The Zabudowicz Collection, 176 Prince of Wales Road, London NW5 3PT

APPLICATION FOR FULL PLANNING PERMISSION & LISTED BUILDING CONSENT

DESIGN & ACCESS STATEMENT ADDENDUM II

DEMOLITION DRAWING - GROUND FLOOR

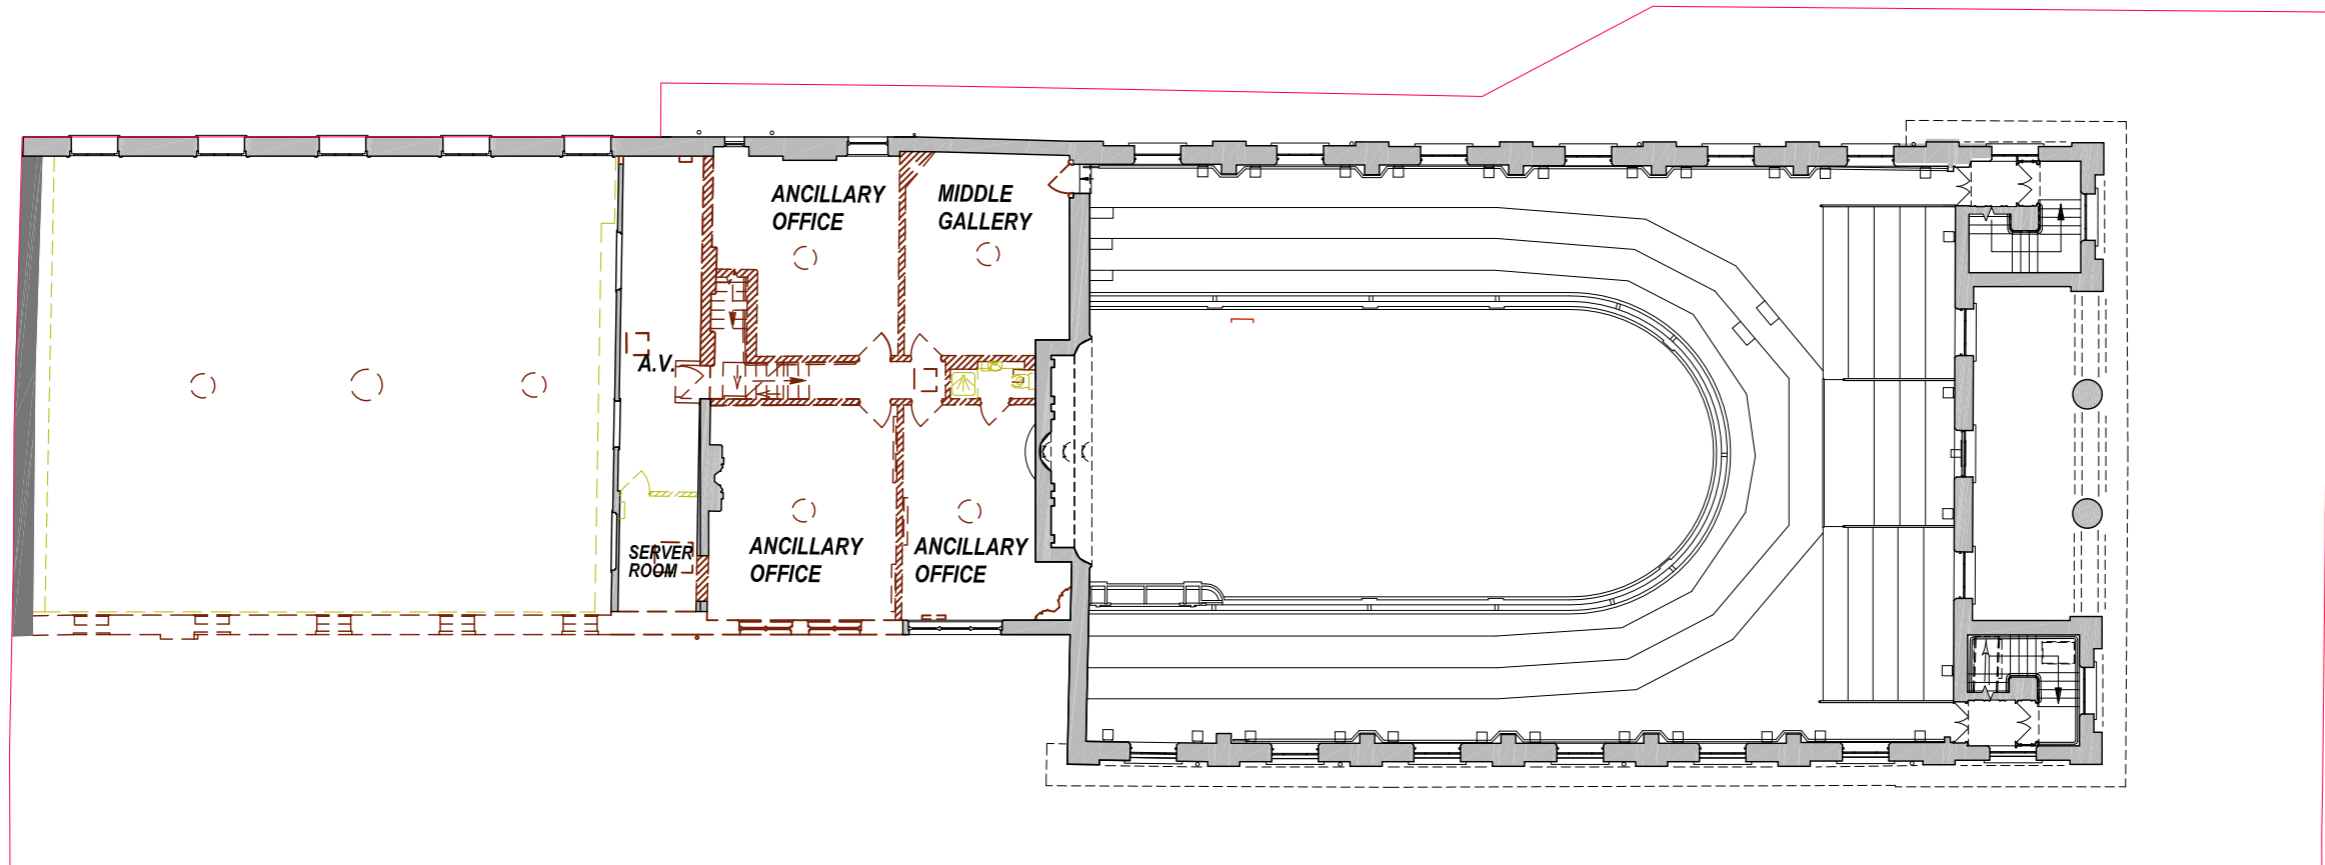
1) Demolition justification

Minimising demolition within the plan and understanding how much of it is absolutely necessary for construction.

- a. AV room (historic gallery);
- b. South wall of Sunday School room and corridor;
- c. Fittings from within the Sunday School room;
- d. Other.

The demolition proposed includes removal of fabric which predates the gallery and partitions added by the gallery during its current use.

To differentiate these two type of fabric removal, the following demolition drawing separates between historic fabric and additions by the gallery.

We have further reduced the extent of demolition of historic fabric and explained the improvements by removing additions.
